Shearwater Petrel 1 & 2/Perdix/Perdix AI/NERD 2 Firmware v71 Release Notes

VERSION 71 2019.09.10

Surface GF is the gradient factor if you were to instantly ascend to the surface

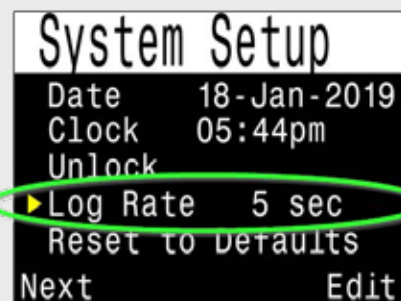
Surface GF display added. This shows the gradient factor if you were to surface immediately. This is different from GF99, which shows your gradient factor at the current depth. Is available:

- On the standard info screens (i.e. after a few right button presses).
- Can be configured on open main screen locations.
- Can be configured as the NDL replacement (appears in-place of NDL once deco is needed)

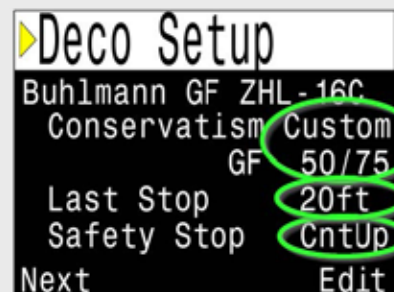
Allows user to set customized gradient factors in OC Rec mode. Previously only fixed sets were available in OC Rec mode.

Allows user to select a 20ft/6m last stop depth in OC Rec mode. Previously the last stop was always 10ft/3m in OC Rec mode.

New OC Rec Deco Options

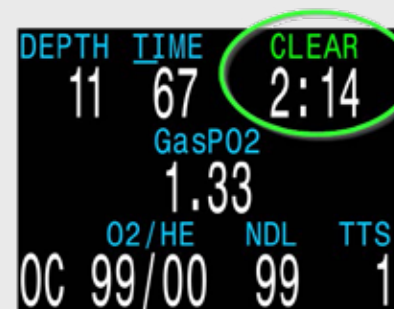
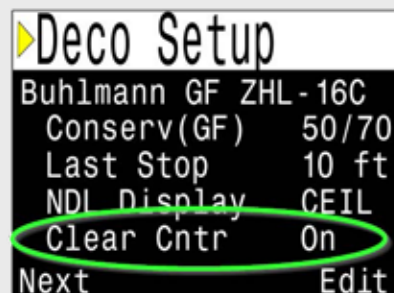
A “Deco Clear” up-counter option has been added.

Available in OC Tec, CC/BO, and OC Rec modes. In OC Rec mode it is available in place of the safety stop. Optional in Tec modes.

When deco clears this counter begins counting up from 0. It is useful for timing additional padding after the mandatory decompression stops. If the dive did not need deco, then begins upon entering the safety stop zone (i.e. shallower than 20ft / 6m).

The “Clear Counter” counts up once deco is clear

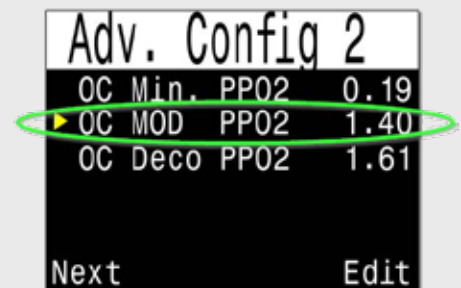
The PPO2 limit options have been changed for OC Tec mode.

Previously, there was an “OC Max PPO2” setting which only defined when the “High PPO2” message occurred, regardless of dive phase (e.g. bottom depth or at deco stop). This confused many users who, quite reasonably, assumed it was the “bottom depth” limit and set it to 1.40. This would result in warnings during deco when the PPO2 was pushed to the 1.60 range.

The “OC Max PPO2” has now been removed and replaced with a “OC MOD PPO2” setting. The MOD setting only applies to the bottom depth phase. The dive computer automatically switches to using the “OC Deco PPO2” limit when within 2 stops of the next deco stop. The “OC Deco PPO2” limit also sets where predictive deco gas switches occur. Also, if the current gas has greater than or equal to 80% oxygen fraction, then the deco limit is used, as the gas is assumed to be a deco gas.

The “OC MOD PPO2” replaces “OC Max PPO2” with different behaviour. Please read the description to left!

After updating, the “OC MOD PPO2” value is set to 1.40 ATA and the “OC Deco PPO2” is unchanged. Defaults are:

OC MOD PPO2 = 1.40 [ATA]
OC Deco PPO2 = 1.61 [ATA]

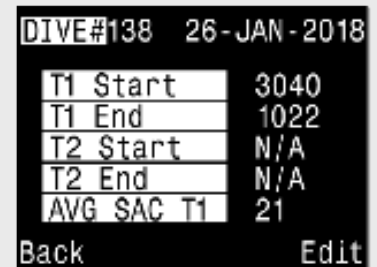
The in-computer dive log now displays start and end tank pressures and average SAC.

The tissues bar graph is now shown on the Tissues Restored screen

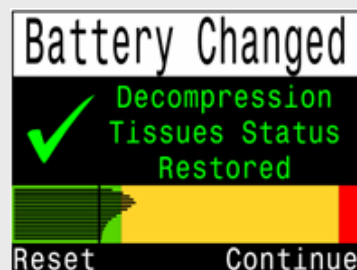
NEW After changing the battery, the current deco tissue loading is shown on the Tissues Restored screen.

NEW On the Tissues Restored screen, a shortcut to reset the tissues is given. If Reset is chosen, a prompt will be displayed to confirm. **Do NOT reset tissues between repetitive dives, as inert gas loading will be lost.**

The mark heading command now requires less button presses

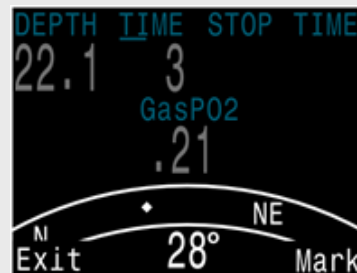
CHANGE Compass mark heading menu moved to reduce button presses. Also, the compass can now be viewed while marking. Operation: when viewing compass a left button press brings up an "Exit/Mark" menu. Right press marks compass, Left press exits to main screen. Previously had to navigate to regular menus to mark the compass.

The offset between current and marked heading is now shown (in this example 16°)

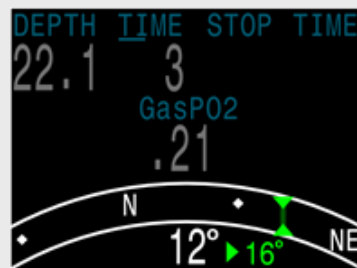
IMPROVE When a heading is marked, the display now shows the offset angle between the current heading and the marked heading. This is useful for navigating patterns. For example, a box pattern requires turns at 90° intervals, while a triangle pattern requires turns at 120° intervals.

On the “Bus Devices” page, choose “View” to see more info and settings

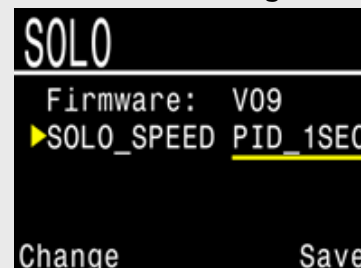
For example, on the SOLO board (solenoid and oxygen controller) the Solenoid Speed setting can be adjusted. Go to “Bus Devices” page on Petrel to access peripheral boards. Settings viewed here are stored on the peripheral device.

If settings are available, they can be changed here. These settings are stored on the peripheral device.
